3. DYNAMIC LOAD ANALYSIS FOR NEW FUEL RACKS IN THE BUFFER POOL

The purpose of this section is to present the structural analysis of New Fuel Storage Racks (FSR) for the Buffer Pool located in the Reactor Building (RB) of the ESBWR.

Figure 5-1. SFP Model

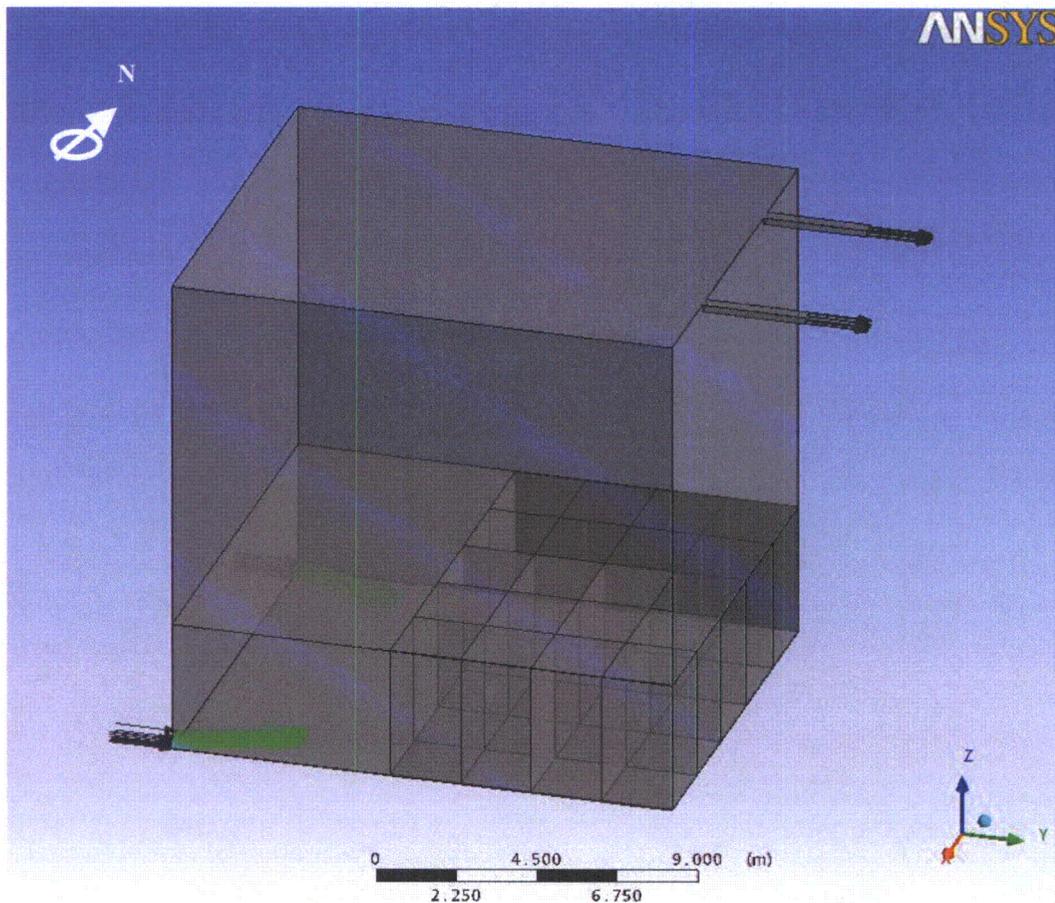
Using NEDO-33373, Figure 5-1, the staff estimated the depth of the pool as 12.5 meters. Assuming that the top of the heated fuel is 3.5 meters from the bottom of the pool, the depth of the highest part of a fuel rod is 9 meters. For water that is 60 degrees C (140 degrees F), the density is 983 kilograms per cubic meter (kg/m^3) (from the ASME Steam Tables, Ref. 34) and the pressure at the 9-meter depth is 1 atmosphere + (density) x (acceleration due to gravity) x (depth) ($P = 101,325 \text{ pascals (Pa)} + 983 \text{ kg/m}^3 * 9.8 \text{ meters per second squared (m/s}^2) * 9 \text{ meters} = 188,026 \text{ Pa}$) or 1.86 atmospheres. The saturation temperature at this pressure (interpolated from the ASME Steam Tables, Ref. 34) is 117.8 degrees C (244 degrees F). This indicates that boiling could occur for temperatures below the 121 degrees C (250 degrees F) criterion set by the applicant.

Figure 5-2. Loss coefficient in Racks

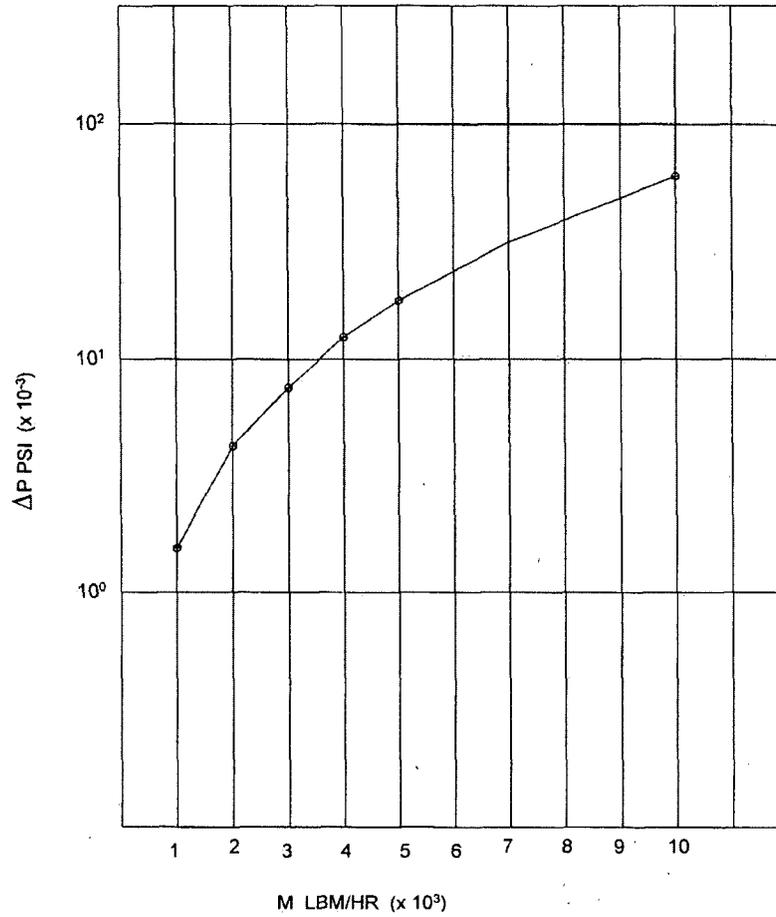
NEDO-33373, Section 5.2 and Appendix H describe the empirical basis for the loss coefficients in the CFD model and their representation in NEDO-33373, Figure 5.2 (repeated in Figure H5-

2). In RAI 9.1-126 (Ref. 34), the staff asked the applicant to clarify NEDC-33373P, Revision 1, Figure 5.2, which is the plot of loss coefficient in the racks and presents the pressure drop as a function of mass flow. In its response dated July 31, 2009 (Ref. 41), the applicant explained that these data are calculated and that the mass flow refers to a single bundle. The applicant also explained that the pressure drop was bounding, because it was based on fuel for existing reactors rather than the shorter ESBWR fuel. The staff concludes that the response is acceptable because the response clarified the information in NEDO-33373, Figure 5.2, and how it is used in the cooling analysis. Therefore, the staff finds the loss coefficient of the CFD model to be acceptable. On the basis of the applicant's response and NEDO-33373 revisions, RAI 9.1-126 is resolved.

Figure 5-9. Streamlines from Inlets to Outlets under the Normal Conditions Case

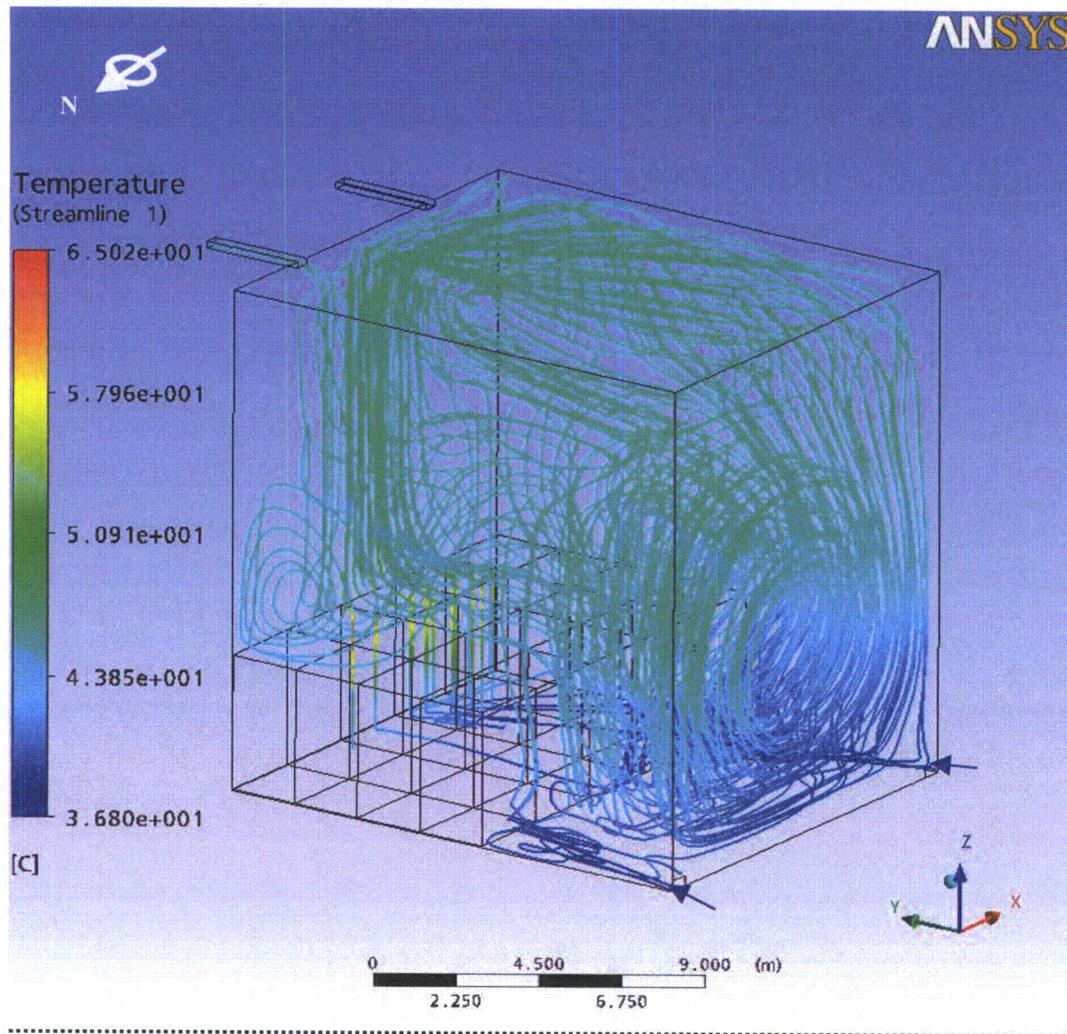
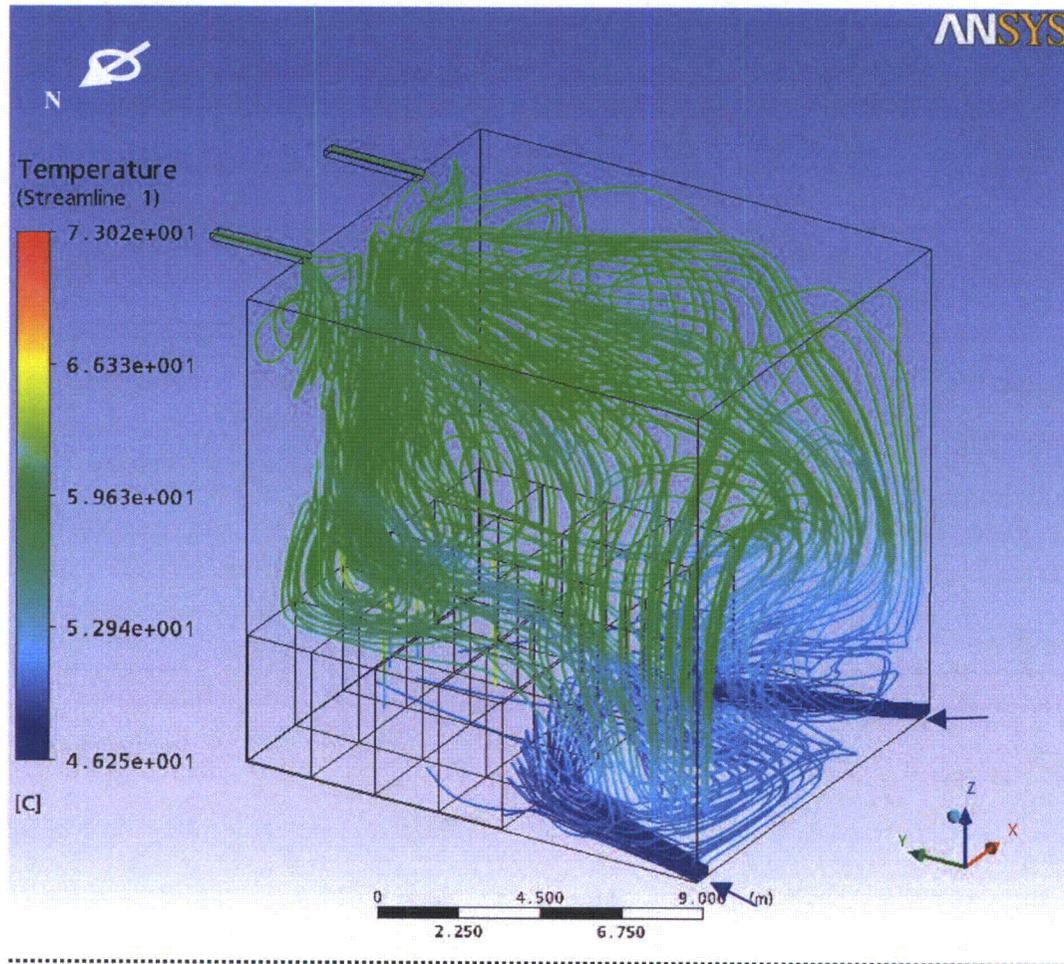
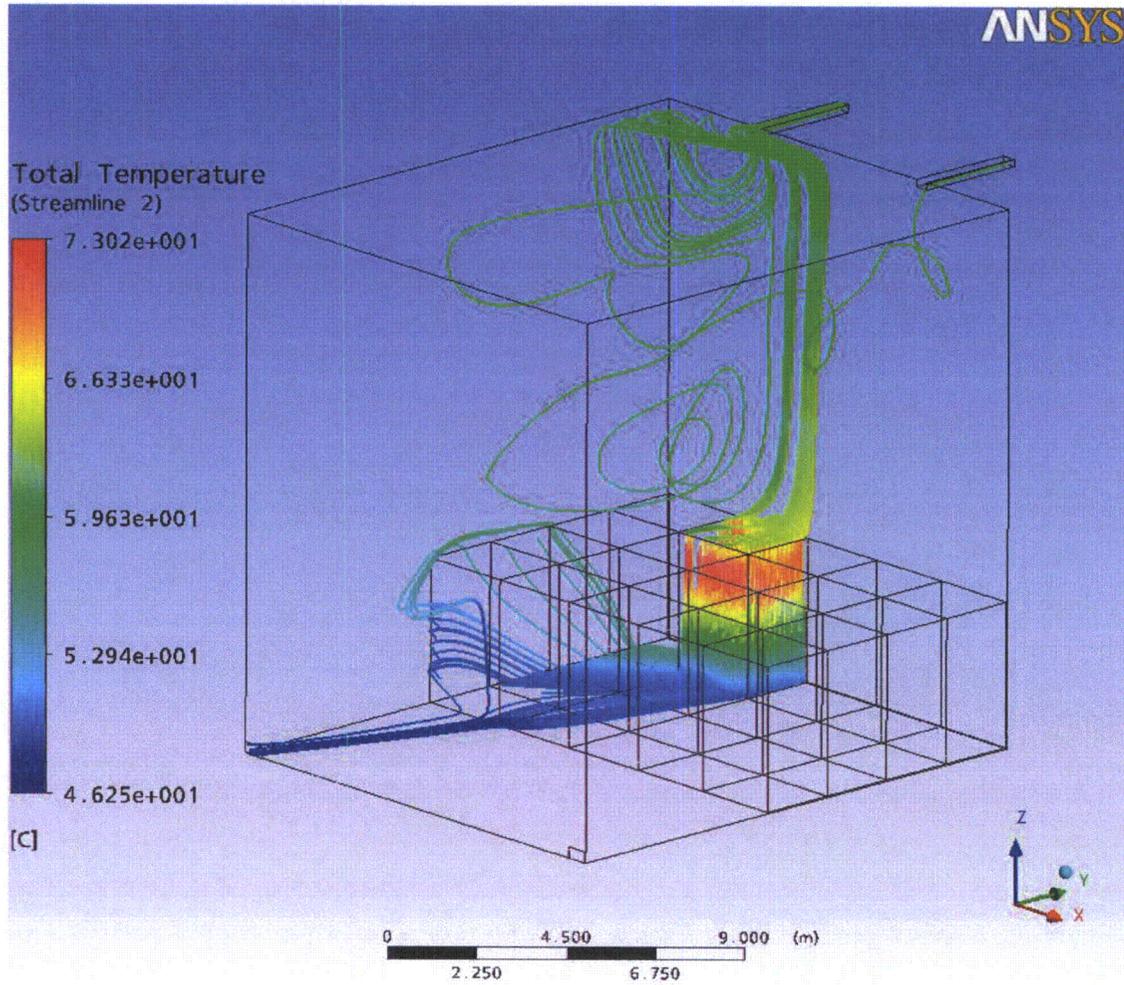
The staff assessed the CFD results for demonstration of natural circulation through the storage racks. In NEDO-33373, Figures 5-9, 5-12, and 5-12a show streamlines from inlets to outlets under normal and abnormal conditions, respectively. The figures show that the pools are well mixed and provide evidence of flow through the racks. This supports the conclusion that there is natural circulation through the racks; therefore, the staff finds that the natural circulation criterion is met.
